Access Compliance Report

Public Rights-of-Way

Intersection ID: 13137	Main Street: CENTRAL_AV	Cross Street: THOMAS_AV	Location: SW
ADA ID: 9BB55AC64A6F	Ramp Type: Perp	Initial Pass/Fail: Fail	Overall Compliance: No
			Severity Score: 26.25

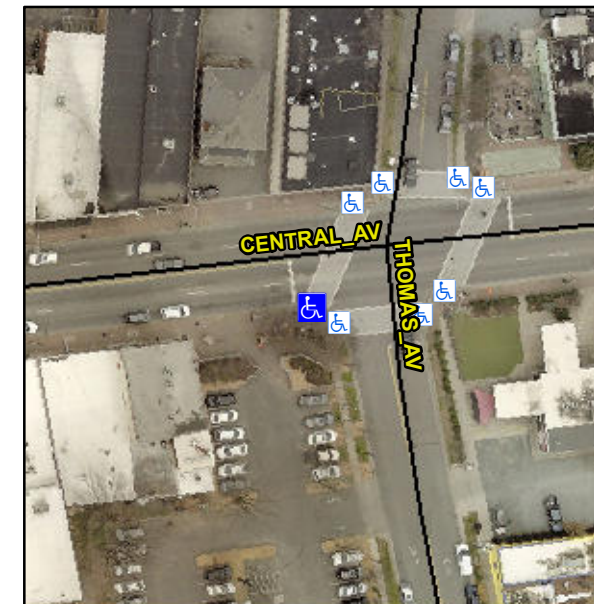
Not Found, R304.2.2, R304.5.3

Compliance	Description	Data	Compliance	Description	Data
N/A	Ramp Length (in)	70.0	No	Ramp Slope (%)	15.4
Yes	Ramp Width (in)	48.0	No	Ramp XSlope (%)	2.2
N/A	Flare Type LT	N/A	N/A	Flare Type RT	N/A
N/A	Flare Slope LT (%)	N/A	N/A	Flare Slope RT (%)	N/A
N/A	Flare Traversable LT?	N/A	N/A	Flare Traversable RT?	N/A
N/A	Landing Length (in)	N/A	N/A	DWS Provided?	N/A
N/A	Landing Width (in)	N/A	N/A	DWS Contrast?	N/A
N/A	Landing Slope (%)	N/A	N/A	DWS Length (in)	N/A
N/A	Landing X Slope (%)	N/A	N/A	DWS Full Width?	N/A
N/A	Landing Curb? (Y/N)	N/A	N/A	DWS Offset (in)	N/A
N/A	Shared Landing?	N/A			
N/A	Gutter Ponding?	N/A	N/A	Gutter Slope (%)	N/A
N/A	Gutter Lip Ht (in)	N/A	N/A	Gutter X Slope (%)	N/A
N/A	Painted X Walk1?	Yes	N/A	Painted X Walk2?	N/A
	X Walk 1 Direction	To NE		X Walk 2 Direction	N/A
N/A	X Walk 1 Width (in)	141.0	N/A	X Walk 2 Width (in)	N/A
	X Walk 1 Slope (%)	3.3		X Walk 2 Slope (%)	N/A
	X Walk 1 X Slope (%)	1.4		X Walk 2 X Slope (%)	N/A

Remove & Replace Entire Ramp.
